#### **2025 MEXICO CITY GRAND PRIX**

From The FIA Formula One Media Delegate Document 7

Title Car Presentation Submissions

#### **Car Presentation – Mexico City Grand Prix** \*SCUDERIA FERRARI HP\*

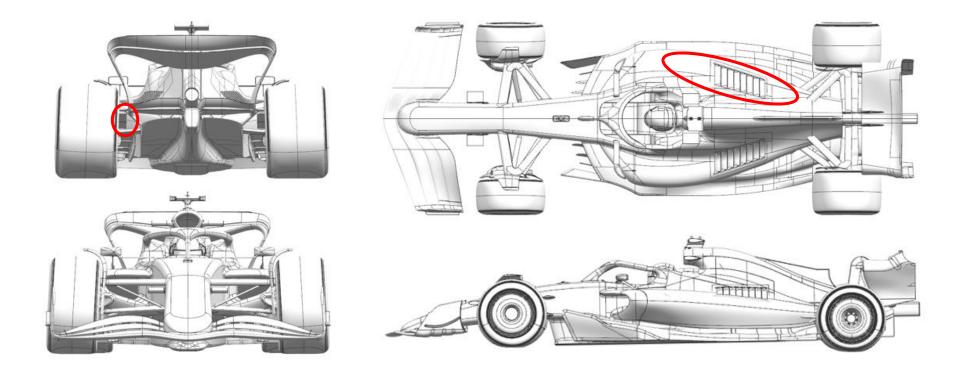
Updated component	Primary reason for update	Geometric differences compared to previous version	Brief description on how the update works (min 20, max 100 words)
1	Cooling Louvres	Circuit specific - Cooling Range	Additional bodywork exit louvres	Specific to the requirements of the Mexico City circuit, these new bodywork exit louvres are extending the top end of the engine cooling capacity, at the expense of car efficiency
2	Rear Corner	Circuit specific - Cooling Range	Enlarged rear brake duct inboard exit	As for the engine cooling options, this update targets an increased cooling capacity for the rear brakes to cope with the requirements of the Mexico City circuit

#### Car Presentation – Mexican Grand Prix Red Bull Racing

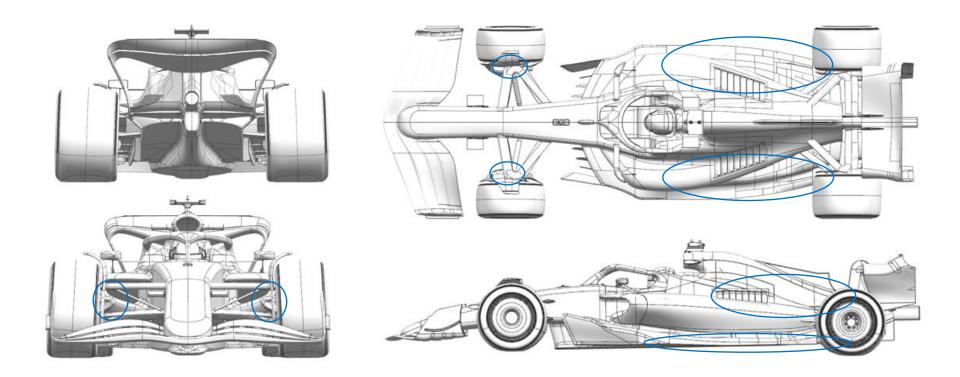
Updated component	Primary reason for update	Geometric differences compared to previous version	Brief description on how the update works (min 20, max 100 words)
1	Front corner	Reliability	Enlarged front brake inlet and outlet ducting	Given the rigours of brake cooling in the reduced atmospheric pressure of Mexico city, larger inlet and exit caps have been prepared for this race to simply recover air mass flow.
2	Engine Cover	Reliability	Redistributed topbody exit areas	In work carried out for the previous cooling revision, more benefit was found from redistributing the exit air and given scope to introduce via an update to existing tooling, this can be deployed in Mexico. In addition, a wider louvre exit panel is available to recover mass flow in the ambient conditions encountered.
3	Floor body	Local load	Subtle revisions to the upper surface at the radiator duct inlet and to the sidepod split line	As a make from the previous specification of floor, a new upper surface rearwards of the outer floor fence plus sidepod split line are offered, the latter to accommodate the sidepod revision. These offer the cooling benefit noted above a small increase in load.

4	Edge wing	Local load	A subtle revision to the leading edge of the floor wing	To draw benefit from the lowered upper floor surface and made from the previous edge wing specification, a revised leading edge region extracts a little more load whilst maintaining flow stability.

#### Car Presentation – Mexico Grand Prix BWT Alpine F1 Team

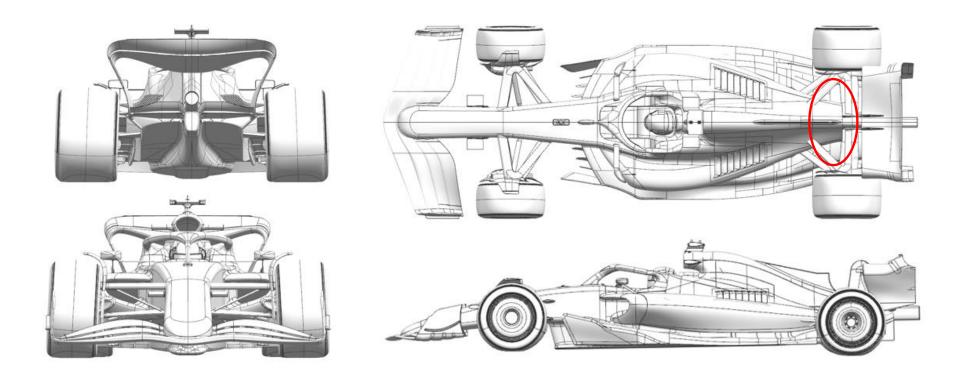
Updated component	Primary reason for update	Geometric differences compared to previous version	Brief description on how the update works (min 20, max 100 words)
1	Coke/Engine Cover	Circuit specific - Cooling Range	Addition of a lip to the bodywork exit	Consequence of the high cooling demand of the Mexico City track, the bodywork exit has been updated to increase the air flow through the coolers.

#### Car Presentation – Mexican Grand Prix Visa Cash App Racing Bulls

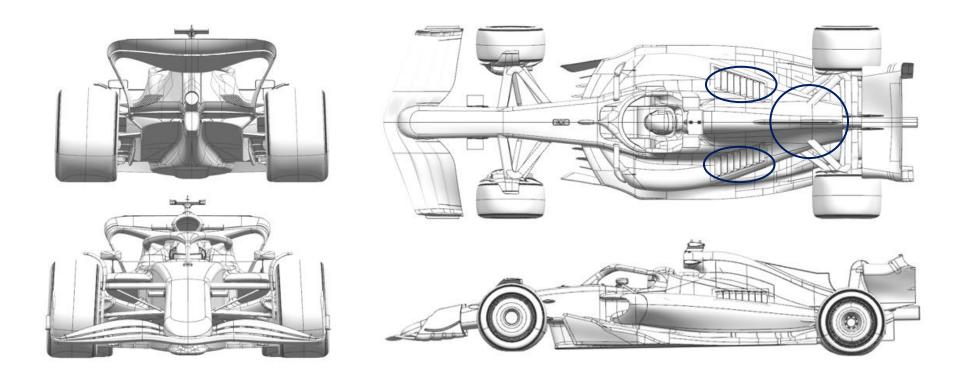
Updated component	Primary reason for update	Geometric differences compared to previous version	Brief description on how the update works (min 20, max 100 words)
1	Coke/Engine Cover	Circuit specific - Cooling Range	Larger rear upper exit	The main cooling exit at the rear of the bodywork has been enlarged, to increase the available engine cooling.
2	Cooling Louvres	Circuit specific - Cooling Range	Larger louvre panel.	The louvre panels used at circuits with high engine cooling requirements have been made larger to increase engine cooling.

# Car Presentation – Mexico City Grand Prix \*ATLASSIAN WILLIAMS RACING\*

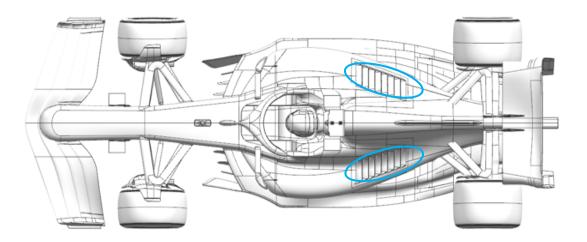
Updated component	Primary reason for update	Geometric differences compared to previous version	Brief description on how the update works (min 20, max 100 words)
1	Cooling Louvres	Circuit specific - Cooling Range	Additional louvre panels are available for this event. The number of louvres is increased compared to past events. Versions are available with 'wide' and 'narrow' louvres.	The increased number/size of louvres increases the flow of air through the cooling system, which helps compensate for the relatively low air density in Mexico City. The higher cooling panels have a negative effect on downforce and drag and therefore will only be used if necessary to cool the PU in the ambient conditions of this weekend.
